# 1989 - 1990 Corvette: Service Bulletin: Convertible: Mounting Bracket Rattle at Rear of Hardtop

**Number:** 90-203-10

**Subject:** Mounting Bracket Rattle at Rear of Hardtop

**Model Year:** 1989-1990 Y Car Convertible

**CORVETTE HARDTOP**  
**BRACKET REAR PIN MOUNTING R/L**  
 ( SERVICE PROCEDURE )

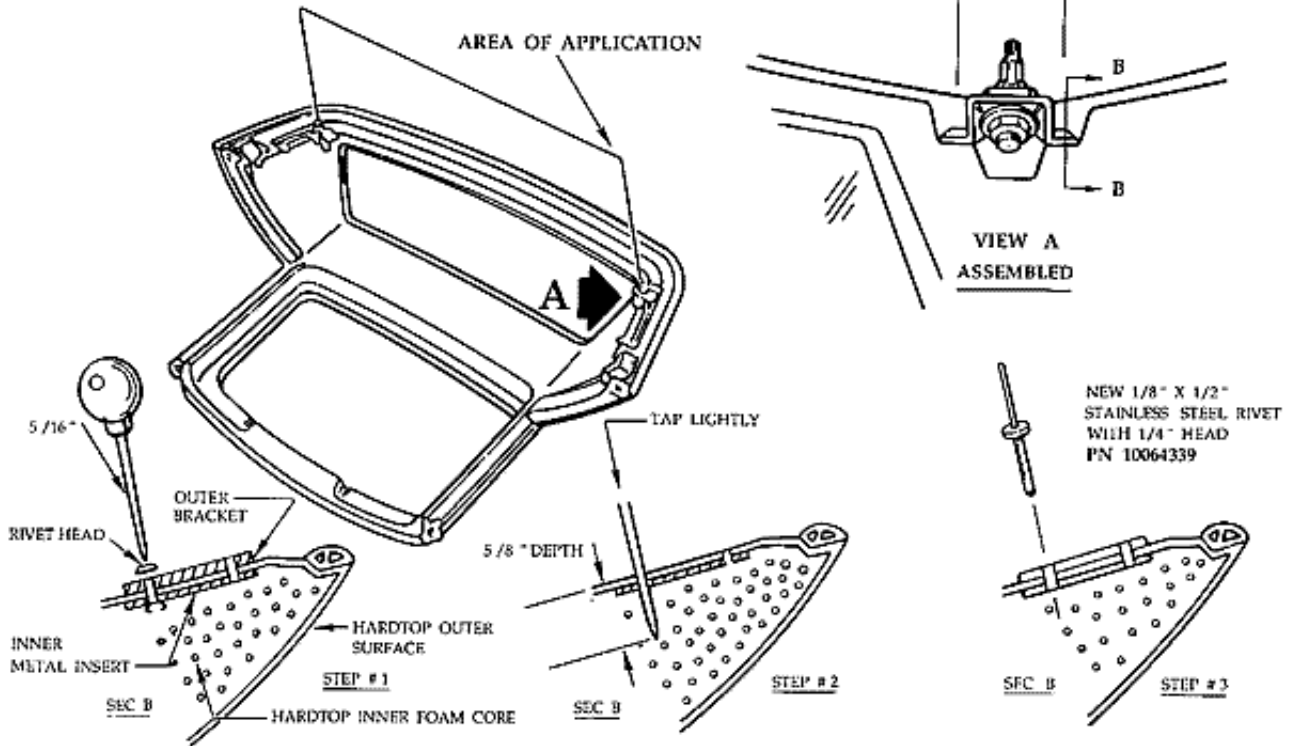
Some 1989 and early 1990 Chevrolet Corvettes (before VIN 106253) equipped with the convertible hardtop option (CC2) may exhibit a rattle at the rear of the hardtop caused by loose hardtop mounting brackets.

Some of these brackets were mounted with rivets which were not long enough to provide enough retention to prevent the rattle.

- STEP #1 DRILL OFF RIVET HEADS, USING A 5/16" DRILL BIT, AND REMOVE BRACKET. (4 RIVETS PER ASM.)
- STEP #2 TAP PREVIOUS RIVET BODIES AND MANDREL 5/8" DOWN INTO HARDTOP INNER FOAM CORE AREA. (4 RIVETS)
- STEP #3 REPOSITION BRACKET AND RE-ATTACH USING NEW RIVET (PN 10064339)

1. Remove hardtop assembly as outlined in the Service Manual.
2. Place the hardtop assembly upside down on a clean protective surface.
3. Using a 5/16 in. carbide tip drill bit and a DRILL STOP SET AT 1/2 INCH, drill the heads off of the four rivets holding the bracket to the hardtop assembly.

4. Using a hammer and a nail or small punch, lightly tap the old rivet bodies into the foam core of the hardtop. The rivets should be driven about 5/8 inch into the foam core.

5. Install new stainless steel rivets, P/N 10064339 to secure the bracket. Part is currently available from GMSPO.
6. Repeat steps 3 through 5 for opposite side of the hardtop assembly.
7. Reinstall roof assembly as outlined in the Service Manual.
